## IEEE P802.11

## Proposed Text Changes to Support Recommendation 96/81

6.2.1.3 MA-UNITDATA-STATUS.indication

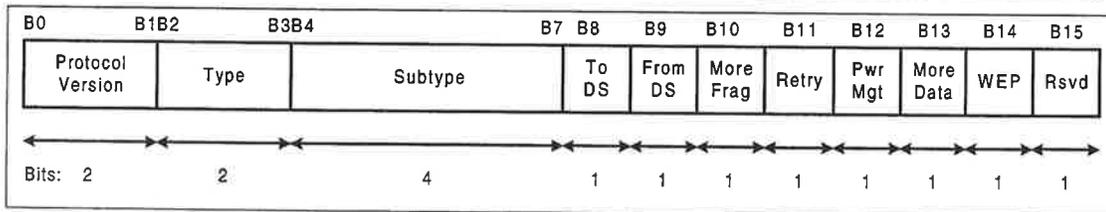
802.11 specifies the following values for transmission-status:

- a) successful,
- b) undeliverable (for unacknowledged directed MSDUs when the aShort-Retry-Max or aLong-Retry-Max is reached),
- c) excessive\_data\_length,
- d) non\_null\_source\_routing,
- e) unsupported\_priority (for priorities other than contention or contentionfree),
- f) unsupported\_service\_class (for service classes other than Reorderable-Multicast or Strictly-Orderedasynchronous),
- g) unavailable\_priority (for contention-free when no point coordinator is available, in which case the MSDU is transmitted with a providedpriority of contention), and
- h) unavailable-service-class (for Strictly-Ordered service when the Power Management mode is not Active).
